Before a Board of Inquiry
MacKays to Peka Peka Expressway Proposal

in the matter of: Notice of requirement for designation and resource consent applications by the NZ Transport Agency for the MacKays to Peka Peka Expressway Proposal

Statement of rebuttal evidence of **Boyden Evans** (Landscape) for the NZ Transport Agency

Dated: 26 October 2012

ANNEXURE 1 – WAIKANAE RIVER PLANTING CONCEPT PLAN

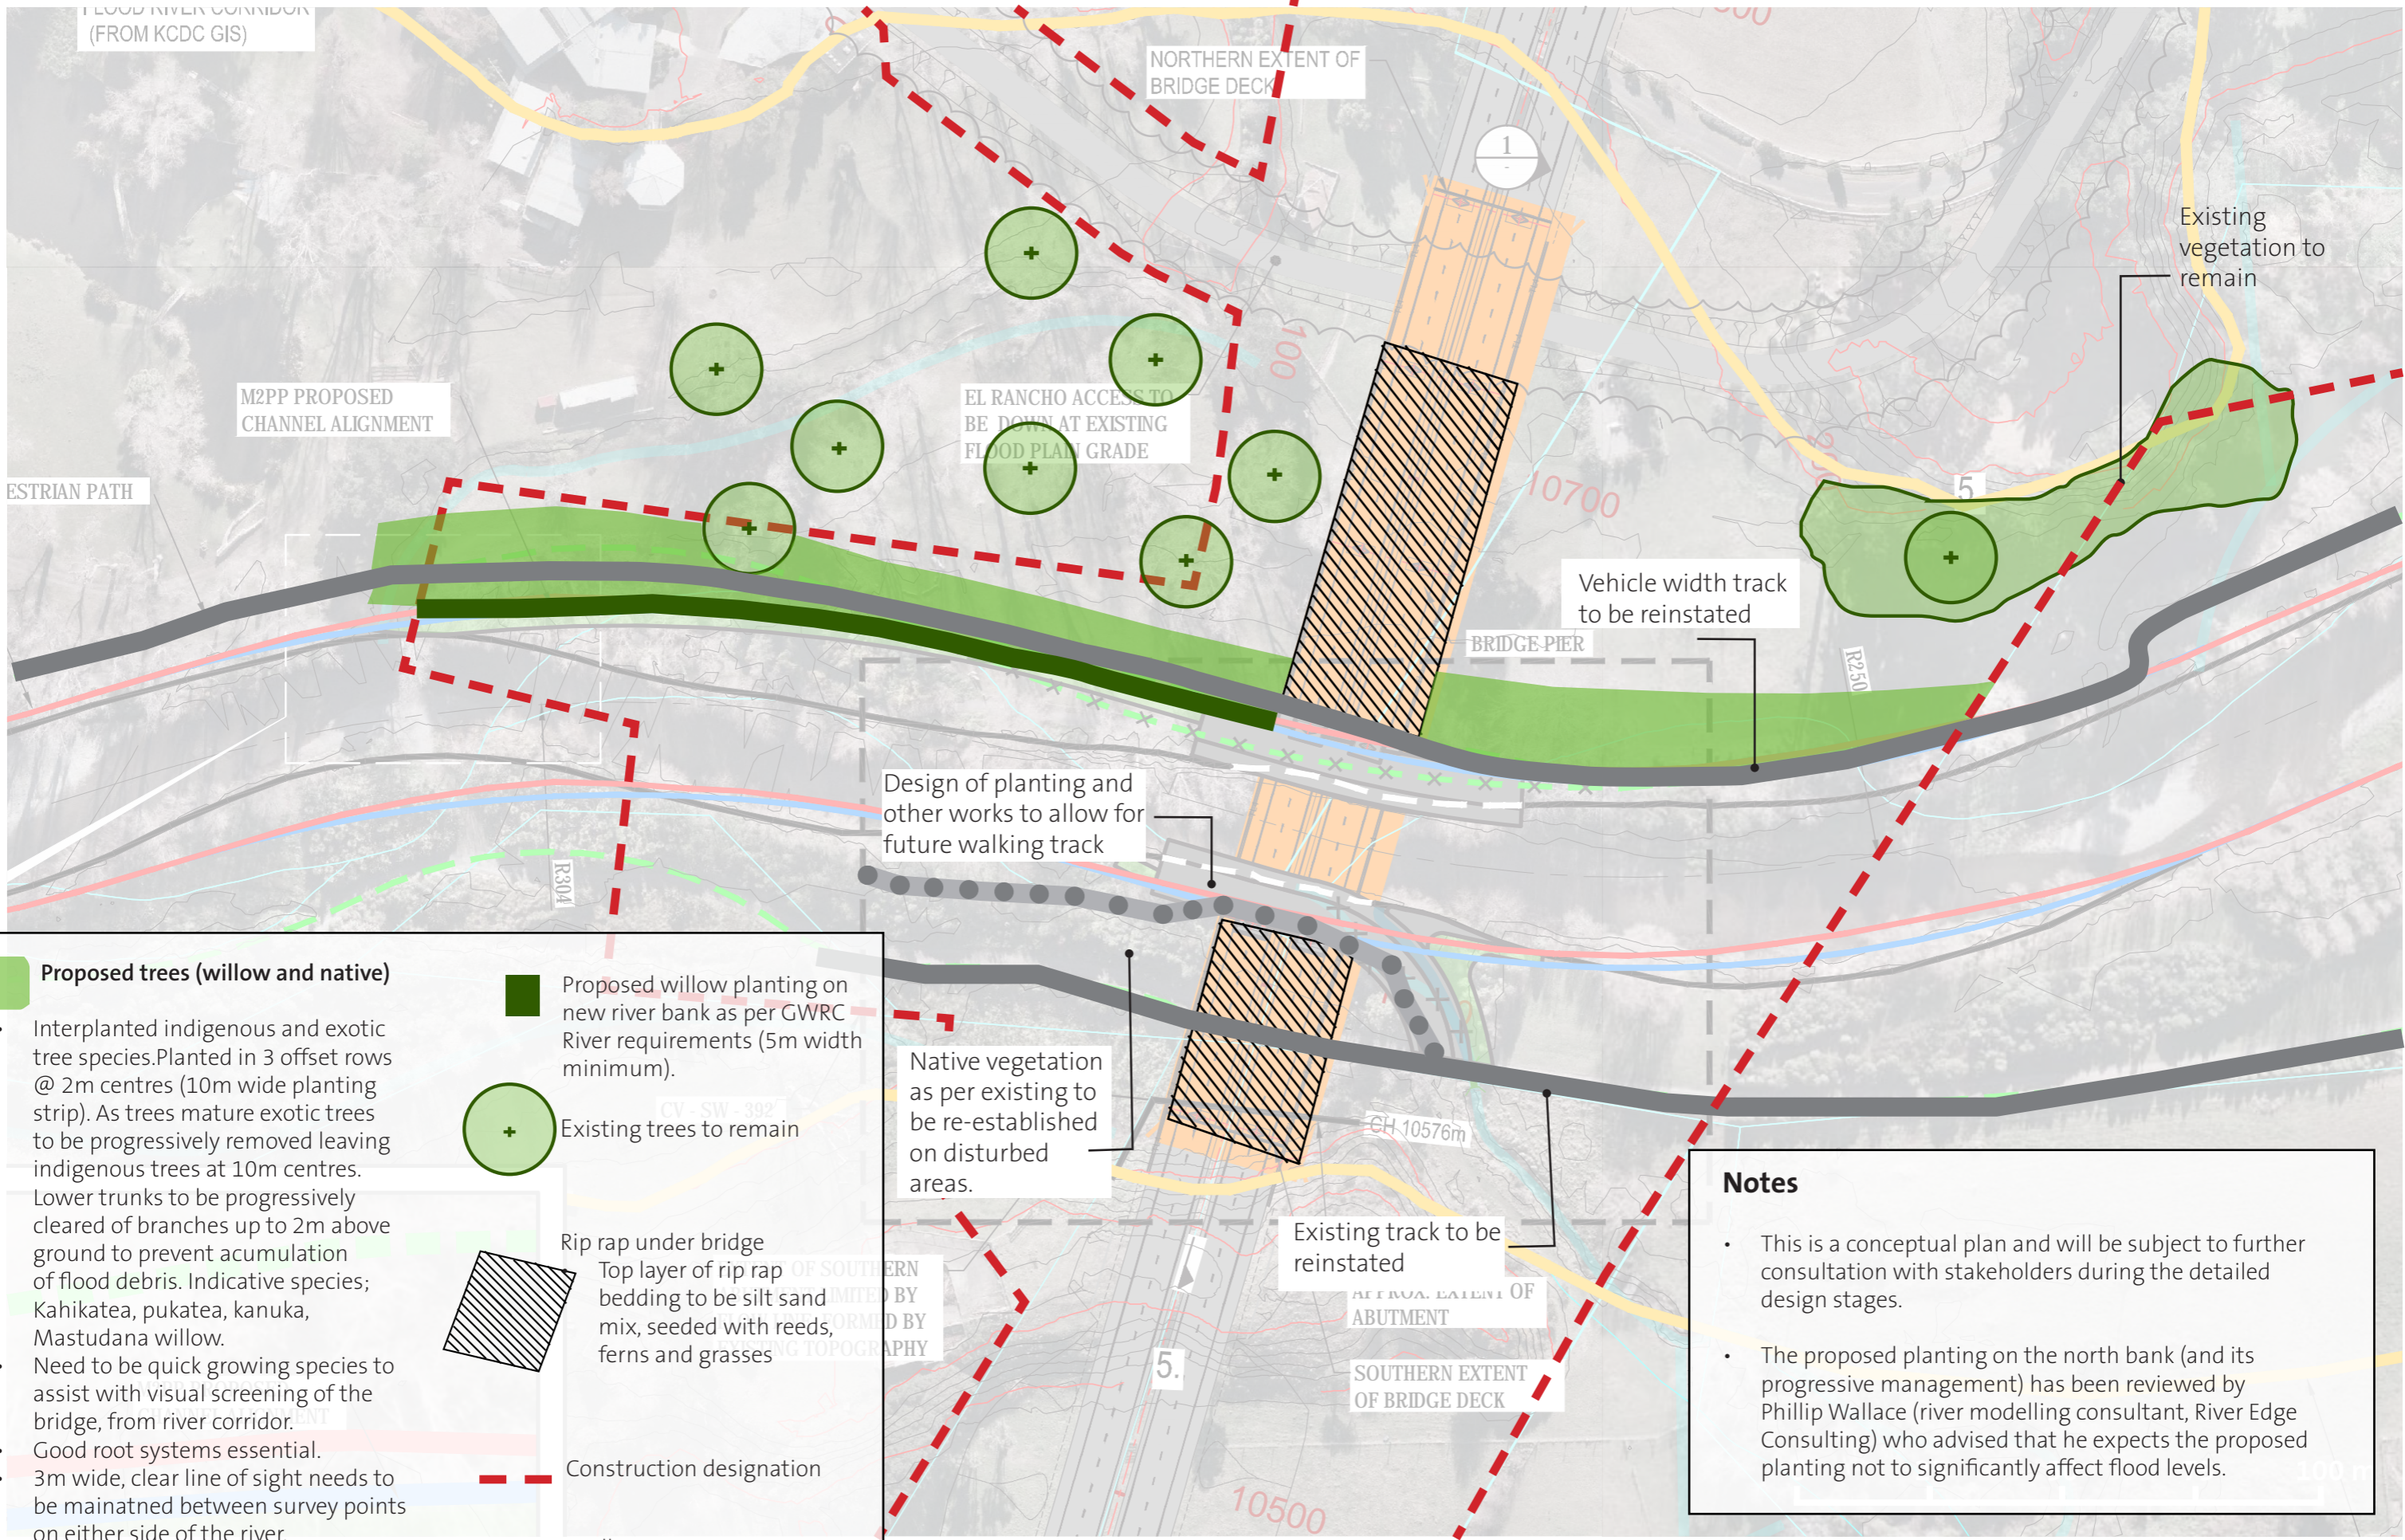
- 65 For one of the final meetings held with the Flood Protection Department, Boffa Miskell produced a planting plan for discussion. Ms Westlake attached a copy of that plan to her evidence, which she has annotated with various comments. She states that she accepts that the discussions held in February 2012, which included the planting plan, are a starting point for the LMP discussions.

- 66 To assist with this process, I have attached as **Annexure 1** to this evidence, an updated copy of the plan tabled in February 2012. This plan has been updated to reflect some further details that came out of the discussions with the GWRC staff, including the points around planting which Ms Westlake has annotated on the copy of the plan attached to her evidence. I suggest this plan (subject to any final changes made to it through conferencing) could be of assistance in final LMP discussions.

**ANNEXURE 2 – WOO ALTERNATIVE ALIGNMENT SKETCH
PLAN WITH TOPOGRAPHY AND EARTHWORKS ADDED**

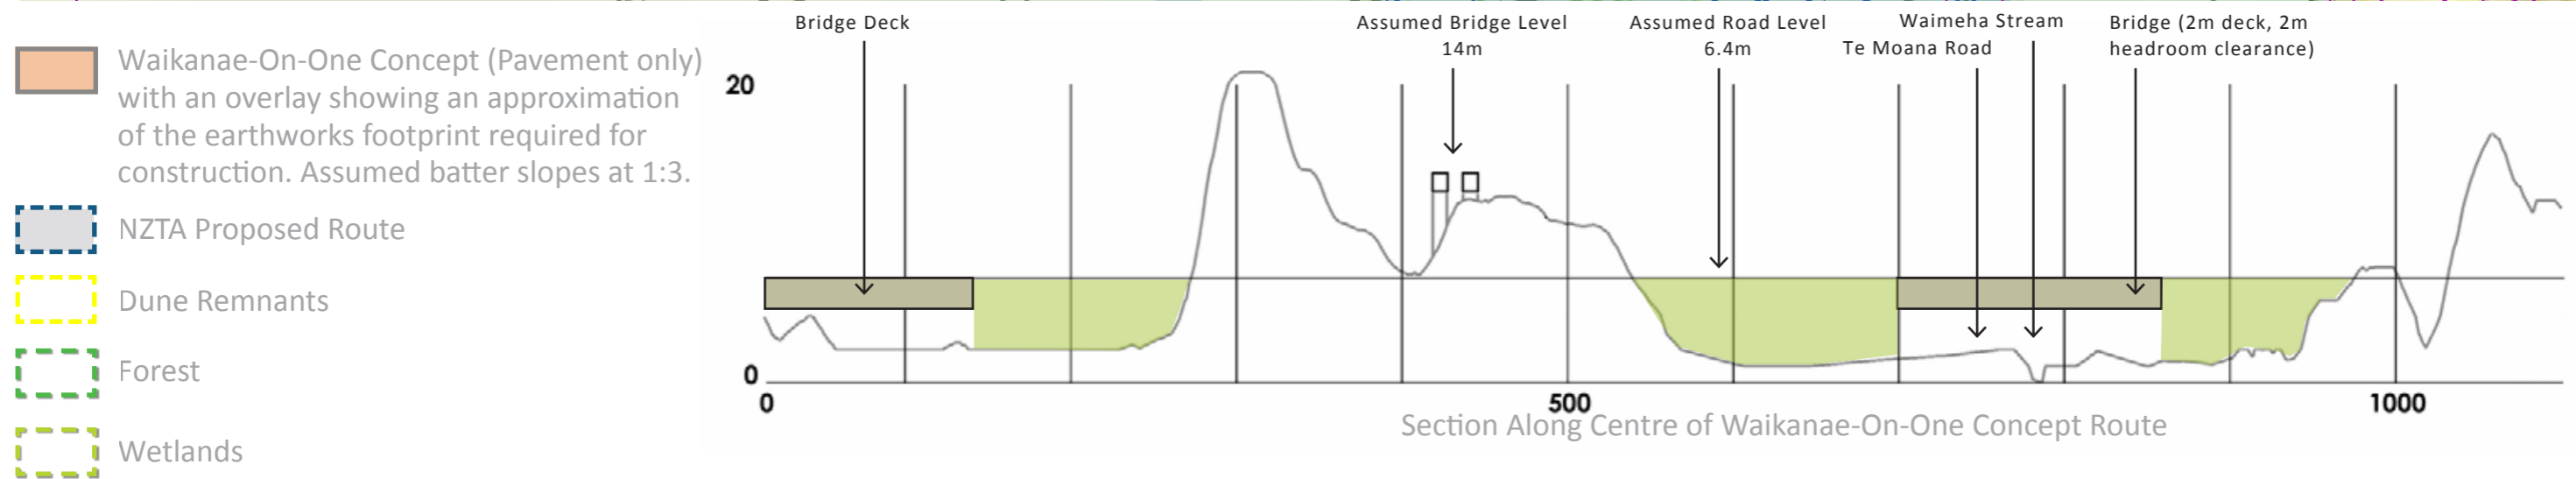
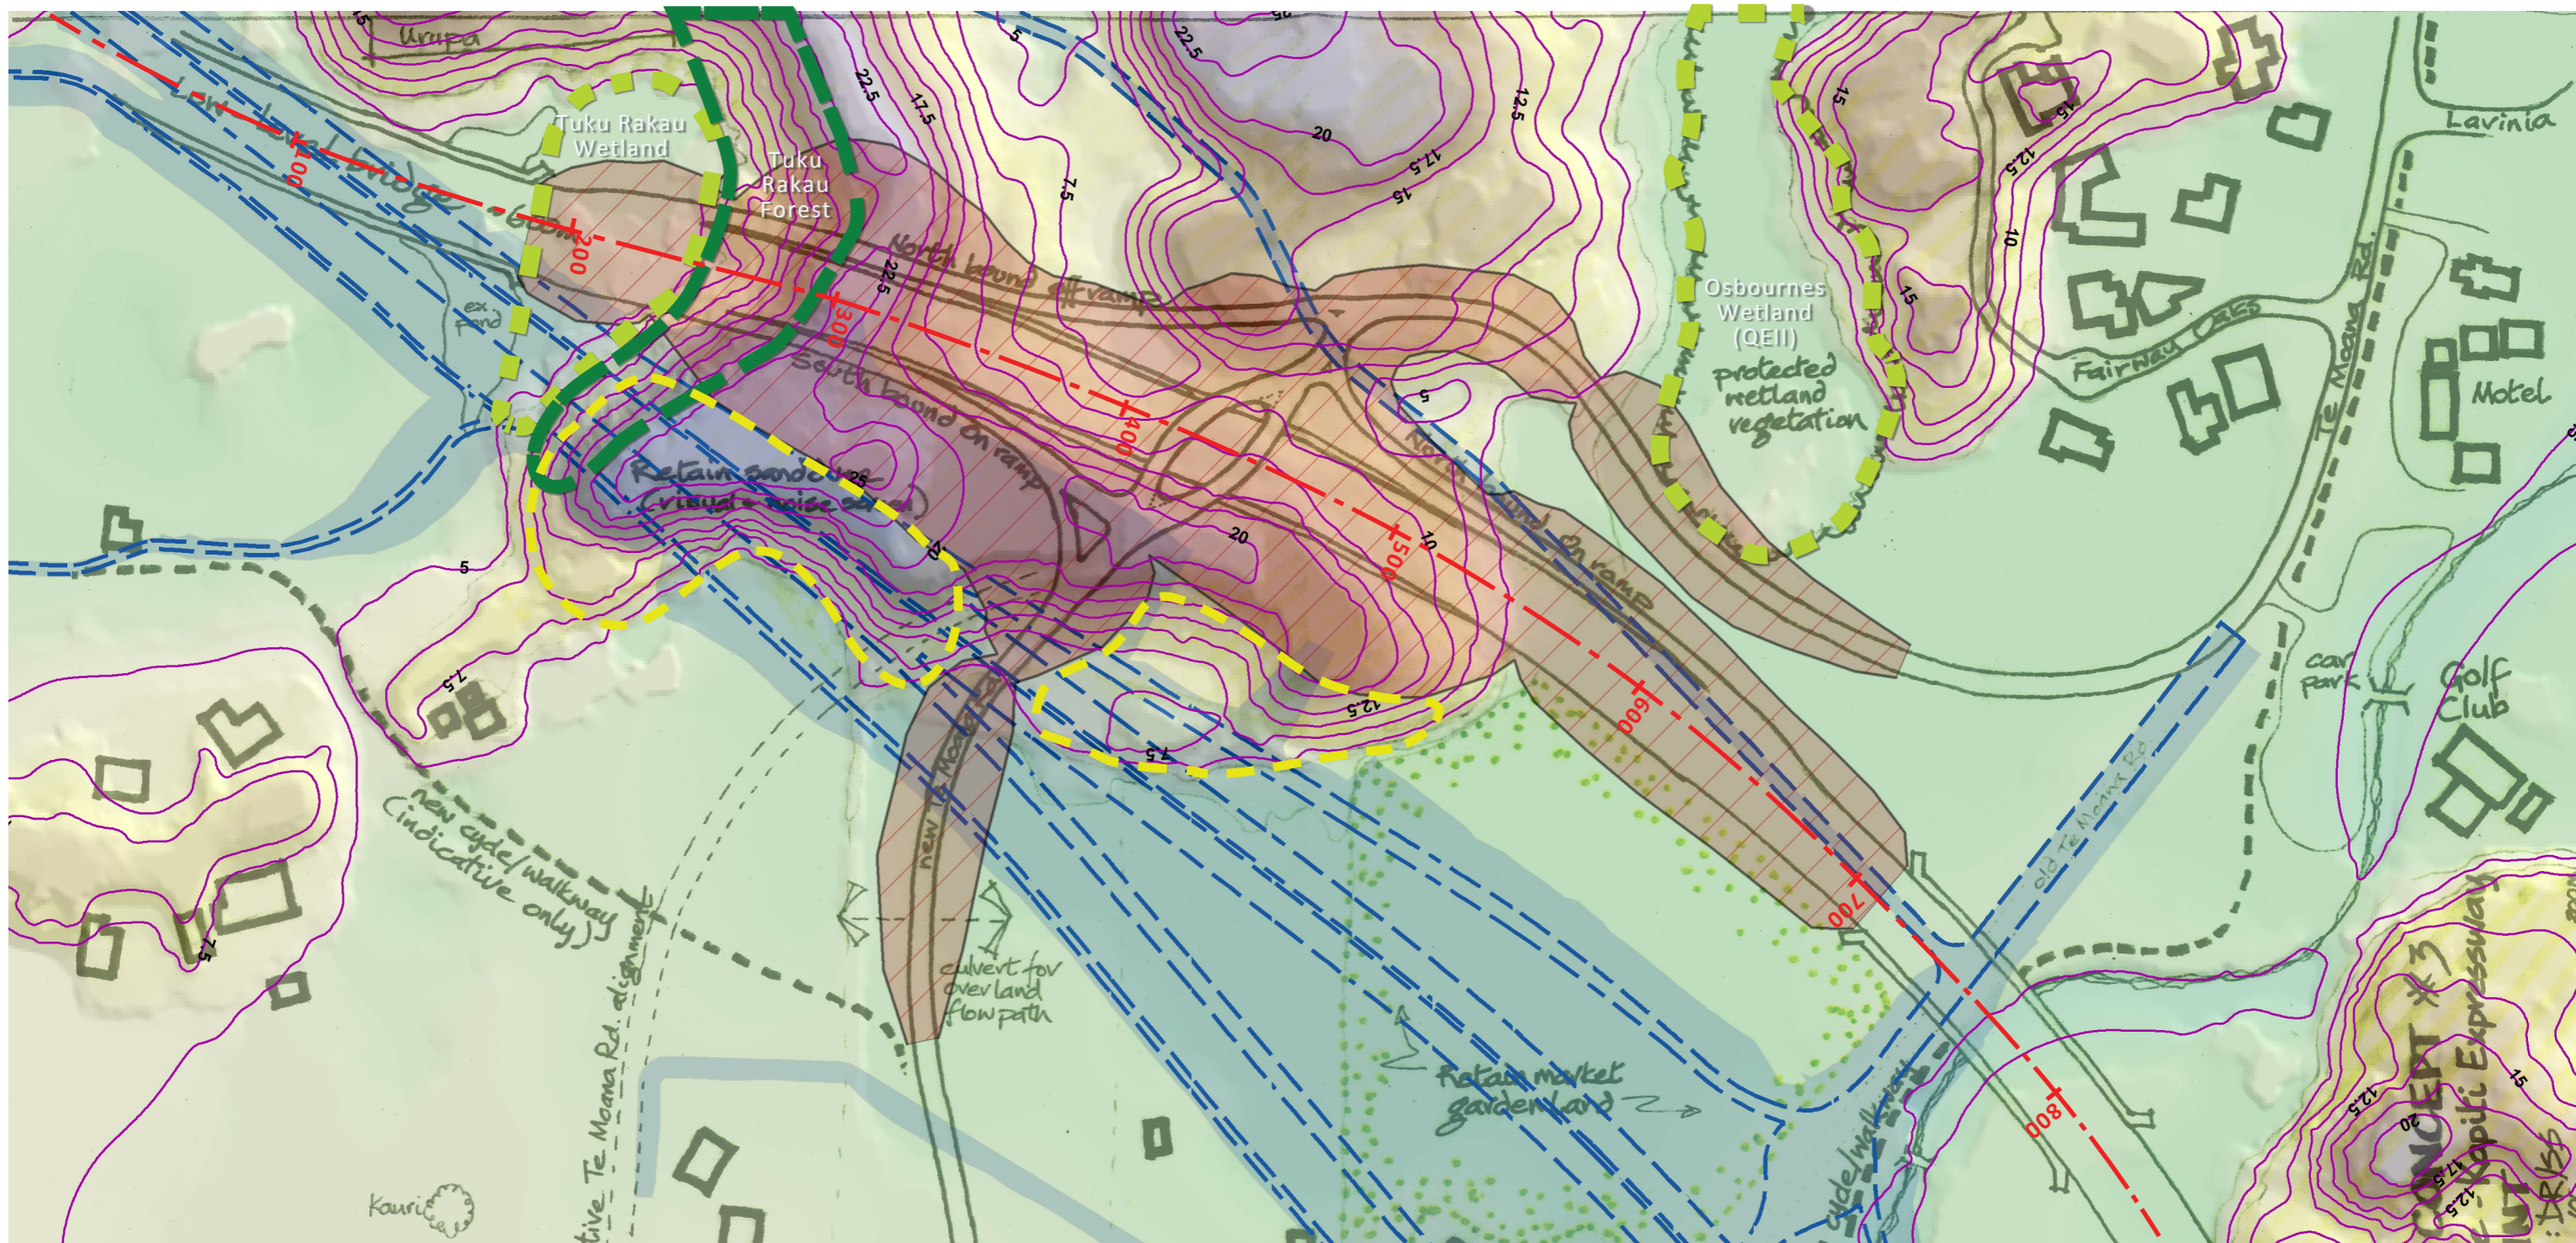
88 To be able to fully **consider Ms Smith’s sketch option I have** had it transposed onto an aerial photograph and have also prepared a long section from the contour information used for the Project to help compare the two proposals. In addition, I have also transposed contours and the Project alignment onto a copy of **Ms Smith’s** plan. I have also discussed this material with **Messrs Nancekivell and Levy**. Those plans are now attached to my evidence (**Annexures 2 and 3**).

90 In simple terms, a lower level bridge over the length shown on the sketch plan would have lesser landscape and visual effects where it crosses the flat market garden area. However, to the south, the **effects are greater because Ms Smith’s** alignment is located further west of the Project alignment and it will require significant cuts to be made through the central part of the 20m high dune. This alignment would cut through the crescent-shaped dune with its stand of regenerating native vegetation (shown as Tuku Rakau forest) and it would also affect the wetland to the south.

91 **Based on the limited amount of analysis possible of Ms Smith’s** sketch proposal, parts of the crescent-shaped dune would be able to be retained on the eastern side of the Expressway. Retention of this remnant section of dune would provide some screening when viewed from the east.
